# Access Compliance Report

## Public Rights-of-Way

### (Curb Ramps)

Intersection ID: 49932	Main Street: WOBURN_RD	Cross Street: PAXTON_RUN_RD	Location: SE
ADA ID: 7340D4A403F6	Ramp Type: Perp	Initial Pass/Fail: Fail	Overall Compliance: No
Severity Score: 12.5			
Codes/Mitigation Info/Possible Solution		Field Measurements/Component Compliance

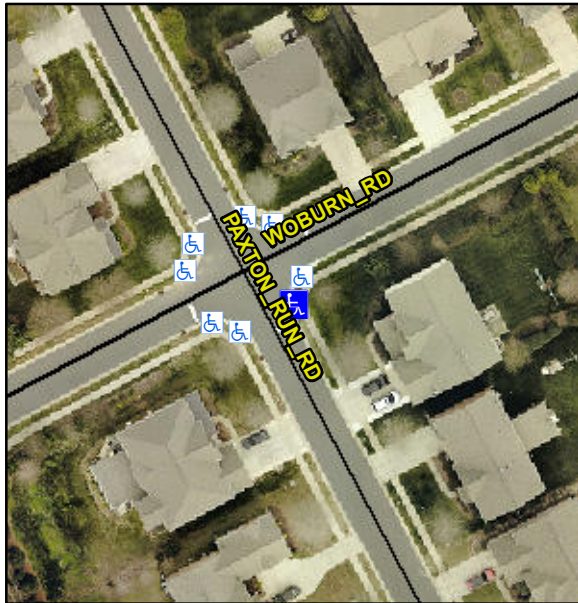
**Not Found, R304.2.2**

Compliance	Description	Data	Compliance	Description	Data
N/A	Ramp Length (in)	46.5	No	Ramp Slope (%)	9.5
Yes	Ramp Width (in)	48.0	Yes	Ramp XSlope (%)	1.1
N/A	Flare Type LT	N/A	N/A	Flare Type RT	N/A
N/A	Flare Slope LT (%)	N/A	N/A	Flare Slope RT (%)	N/A
N/A	Flare Traversable LT?	N/A	N/A	Flare Traversable RT?	N/A
N/A	Landing Length (in)	N/A	N/A	DWS Provided?	N/A
N/A	Landing Width (in)	N/A	N/A	DWS Contrast?	N/A
N/A	Landing Slope (%)	N/A	N/A	DWS Length (in)	N/A
N/A	Landing X Slope (%)	N/A	N/A	DWS Full Width?	N/A
N/A	Landing Curb? (Y/N)	N/A	N/A	DWS Offset (in)	N/A
N/A	Shared Landing?	N/A			
N/A	Gutter Ponding?	N/A	N/A	Gutter Slope (%)	N/A
N/A	Gutter Lip Ht (in)	N/A	N/A	Gutter X Slope (%)	N/A
N/A	Painted X Walk1?	No	N/A	Painted X Walk2?	N/A
	X Walk 1 Direction	To SW		X Walk 2 Direction	N/A
N/A	X Walk 1 Width (in)	N/A	N/A	X Walk 2 Width (in)	N/A
	X Walk 1 Slope (%)	5.8		X Walk 2 Slope (%)	N/A
	X Walk 1 X Slope (%)	3.2		X Walk 2 X Slope (%)	N/A

**Remove & Replace Entire Ramp.**
